April 27, 2000  
IPN-00-033

Subject: **Indian Point 3 Nuclear Power Plant**  
**Docket No. 50-286**  
**Proposed Technical Specification Changes Associated With**  
**Pressure-Temperature and Overpressure Protection System**  
**Limits for Up To 16.2 Effective Full Power Years**

**PROPOSED REVISIONS TO TECHNICAL SPECIFICATION CHANGES ASSOCIATED  
WITH PRESSURE-TEMPERATURE AND OVERPRESSURE PROTECTION SYSTEM  
LIMITS FOR UP TO 16.2 EFFECTIVE FULL POWER YEARS**

FIGURE 3.1.A-5

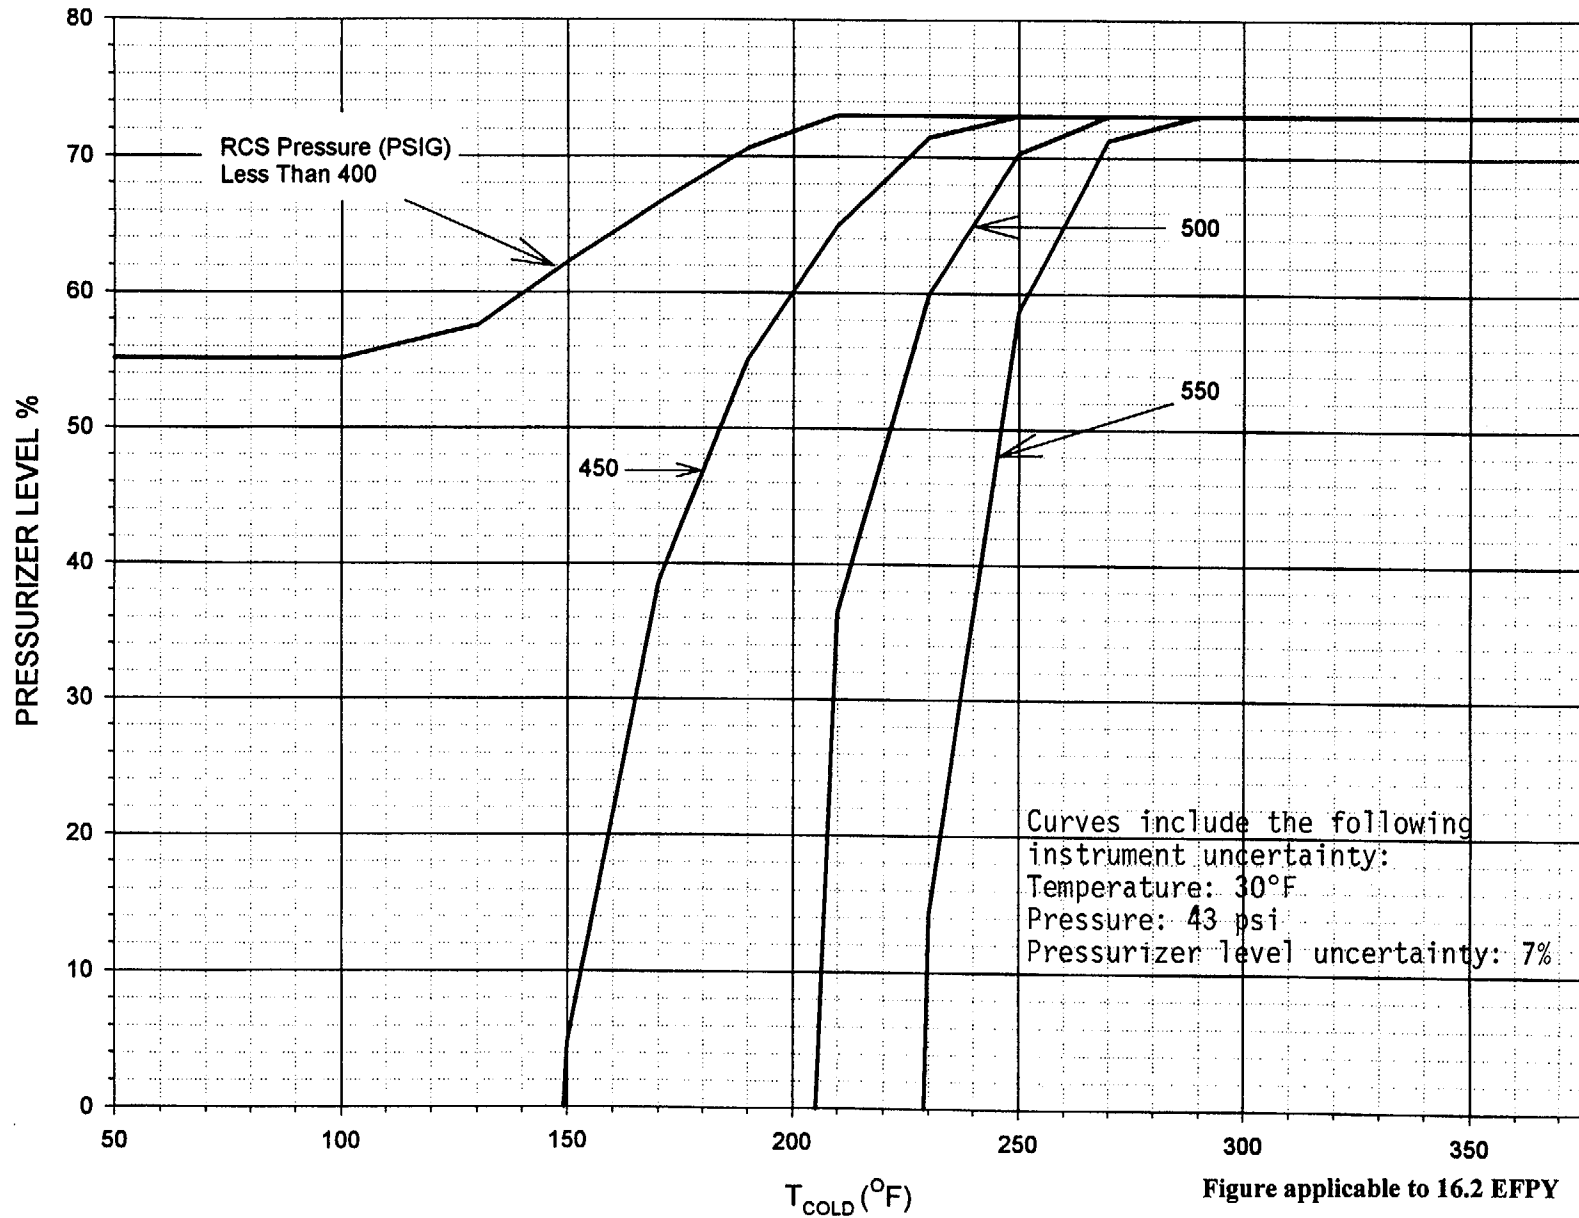
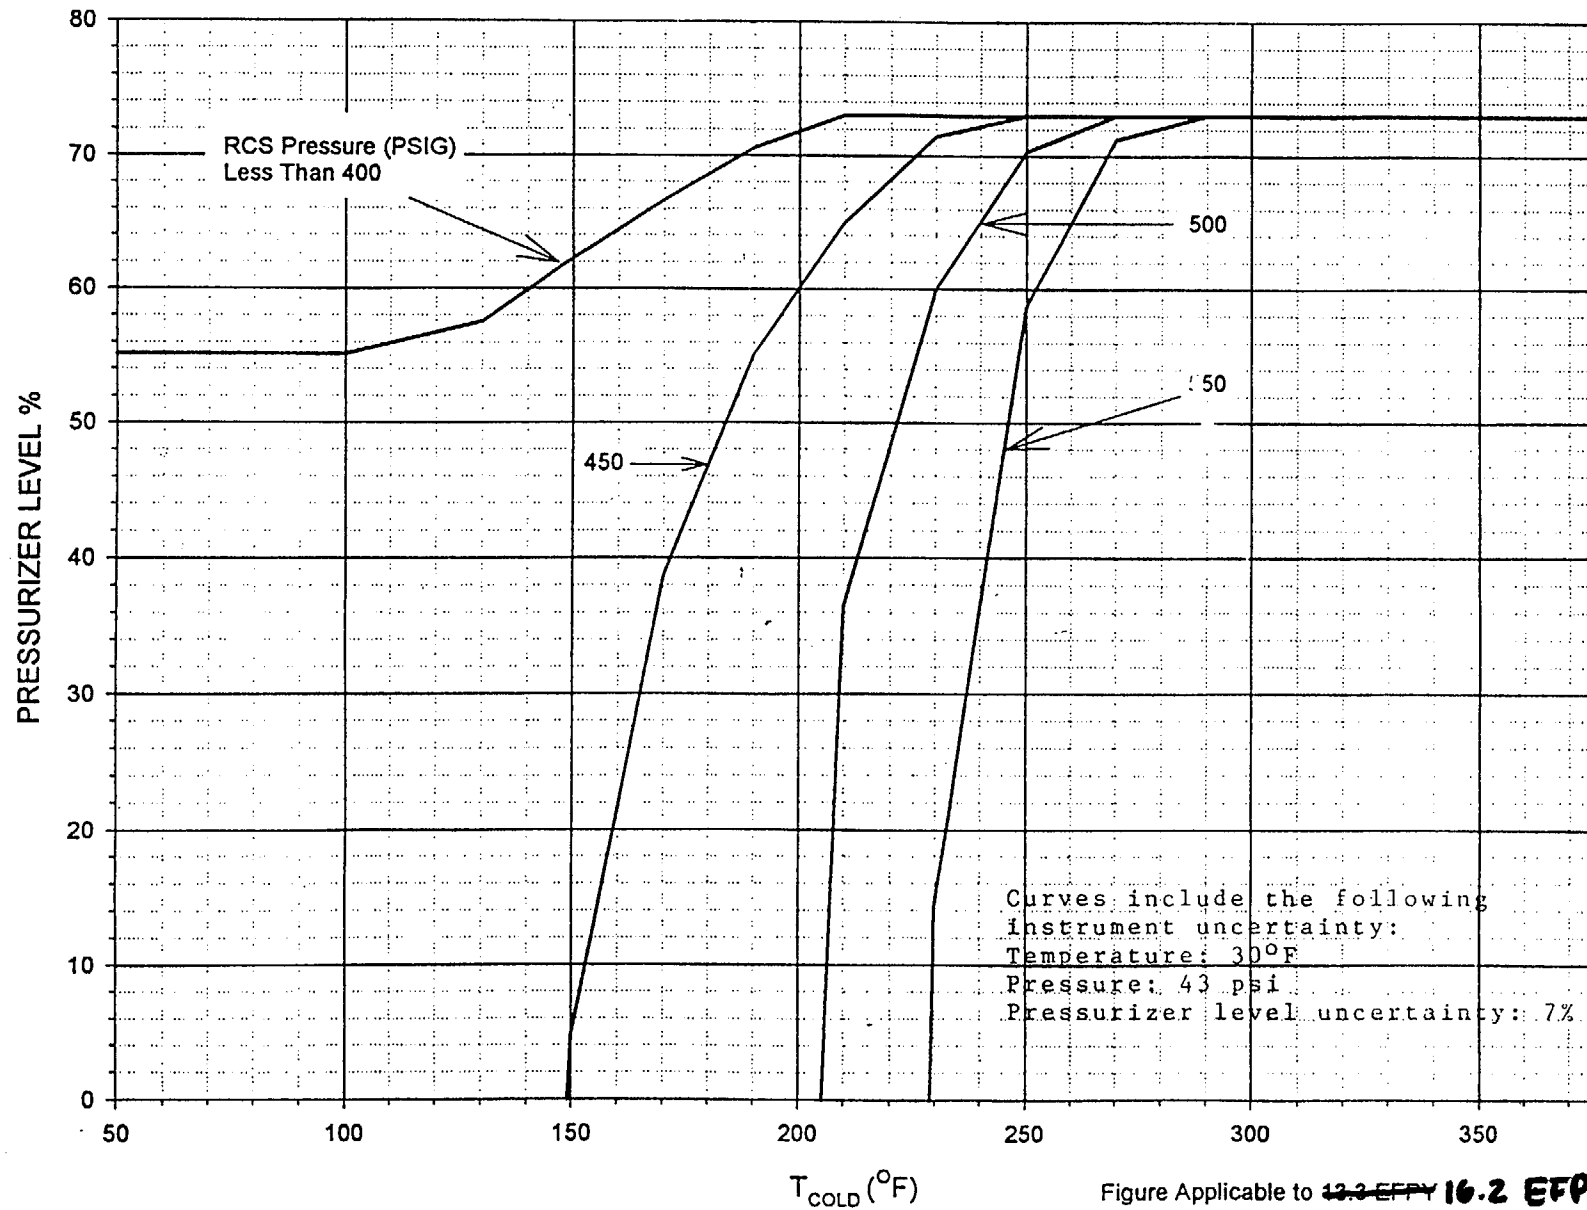
4. **Figure 3.1.A-5**

Replace current figure title with:

Replace caption in low right-hand corner with:

"Figure applicable to 16.2 EFPY"

Pressurizer Limitations for OPS Inoperable  
(Up to one charging pump capable of feeding RCS), ~~13.3 EFPPY~~ **16.2 EFPPY**

Figure Applicable to ~~13.3 EFPPY~~ **16.2 EFPPY**

Pressurizer Limitations for OPS Inoperable (Up to one charging pump capable of feeding RCS), 16.2 EFPY

Figure applicable to 16.2 EFPY

FIGURE 3.1.A-6

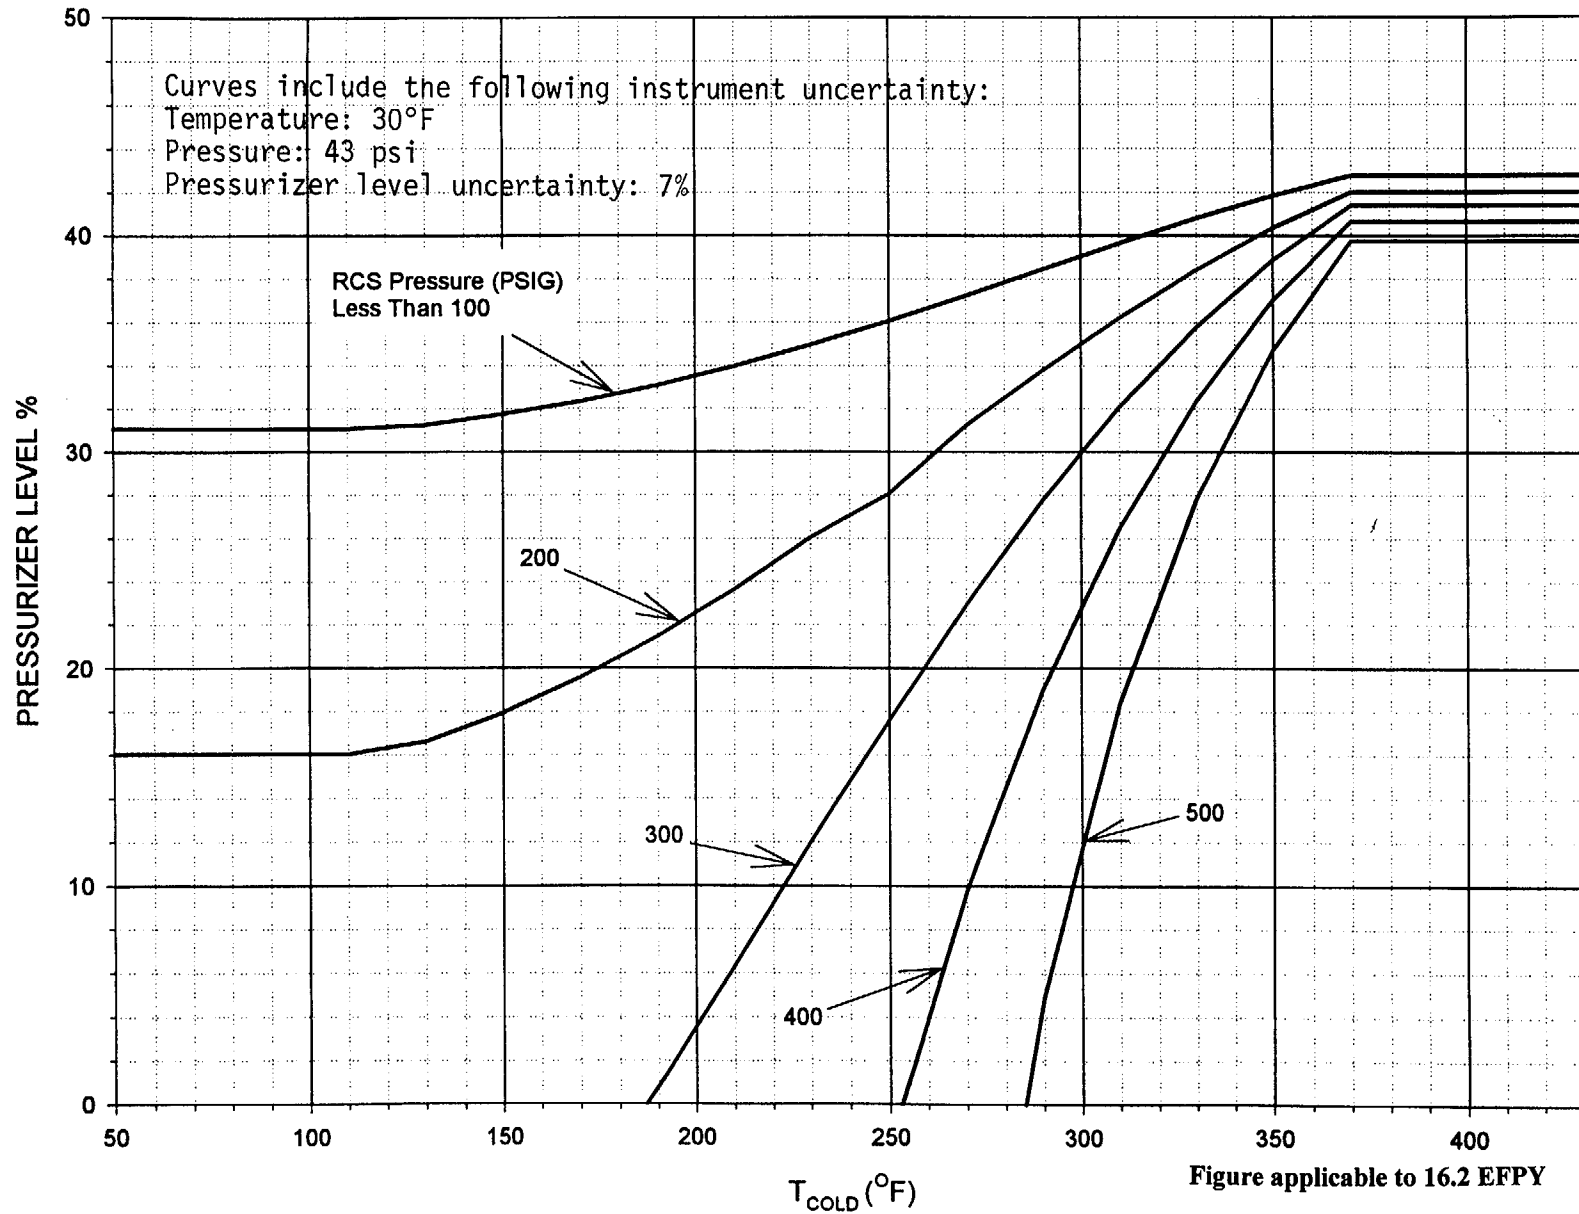
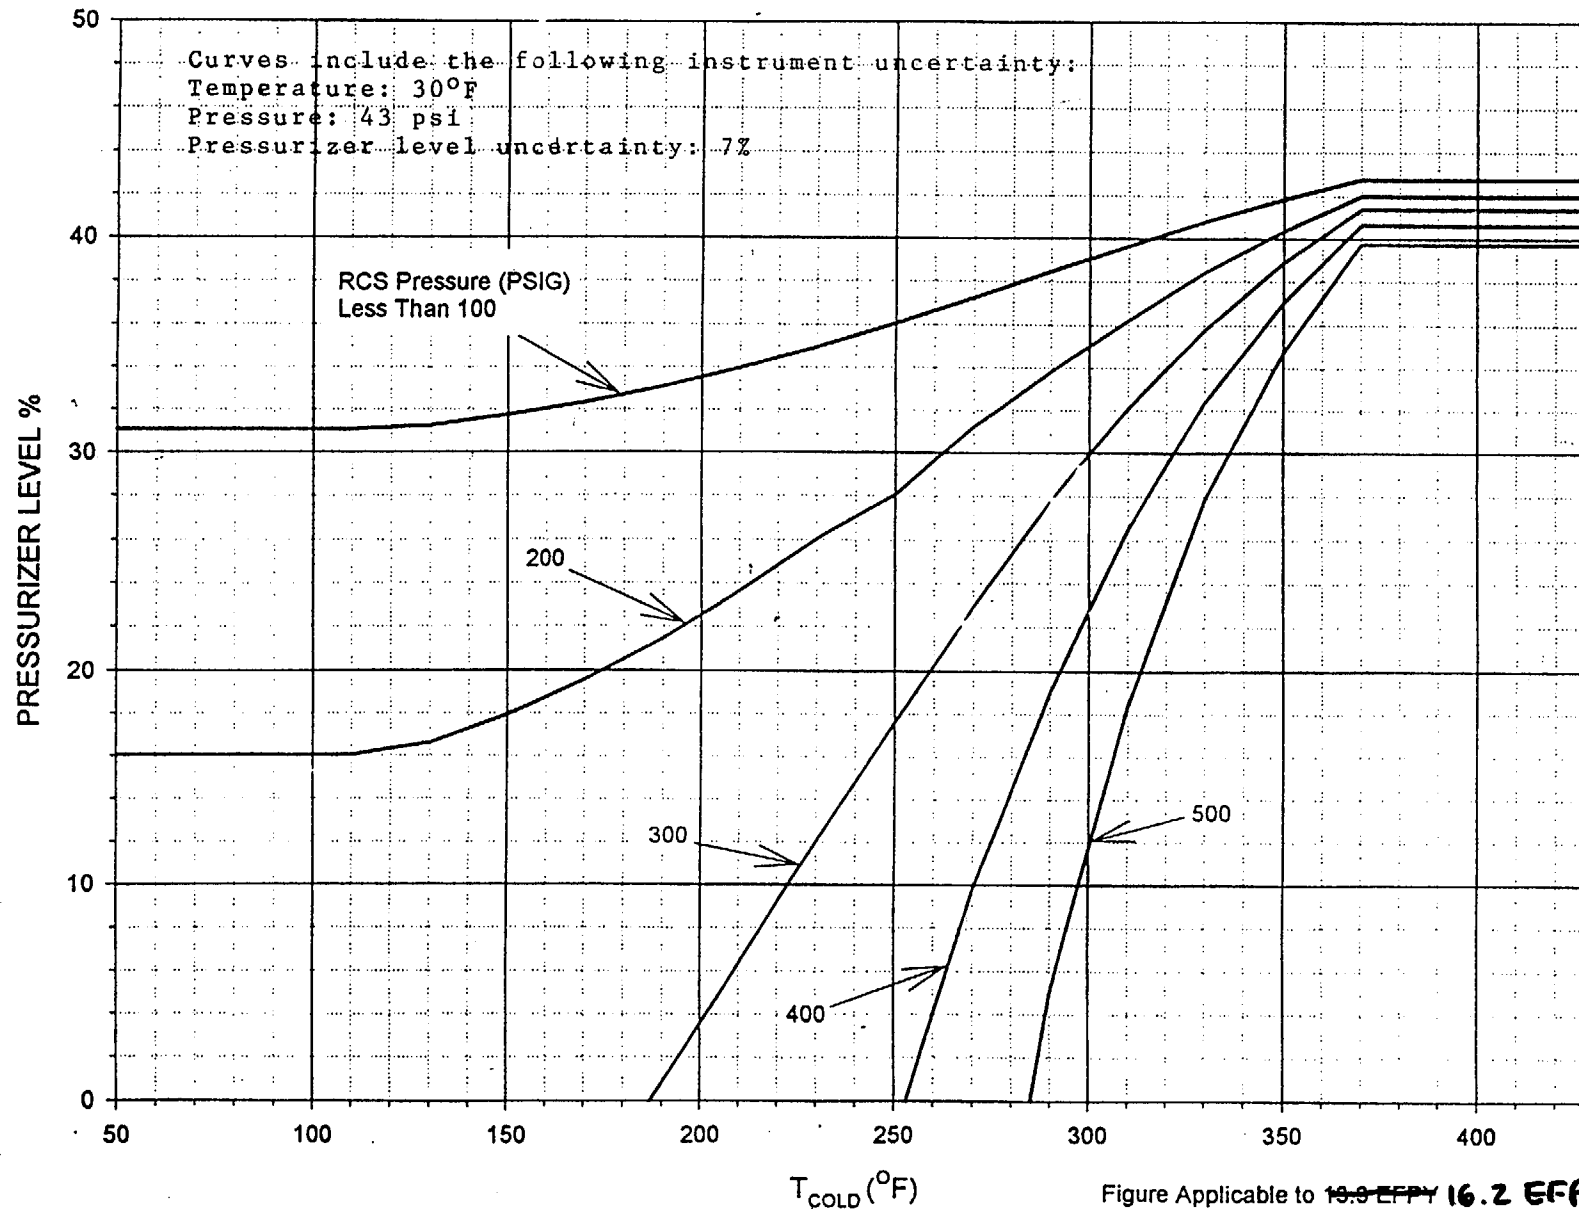
5. **Figure 3.1.A-6**

Replace current figure title with:

Replace caption in low right-hand corner with:

"Figure applicable to 16.2 EFPY"

Pressurizer Limitations for OPS Inoperable (up to three charging pumps and/or one safety injection pump capable of feeding RCS), ~~12.3 EFY~~ **16.2 EFY**

Figure Applicable to ~~12.3 EFY~~ **16.2 EFY**

Pressurizer Limitations for OPS Inoperable  
(up to three charging pumps and/or one safety injection pump capable of feeding RCS), 16.2 EFY

Figure applicable to 16.2 EFY
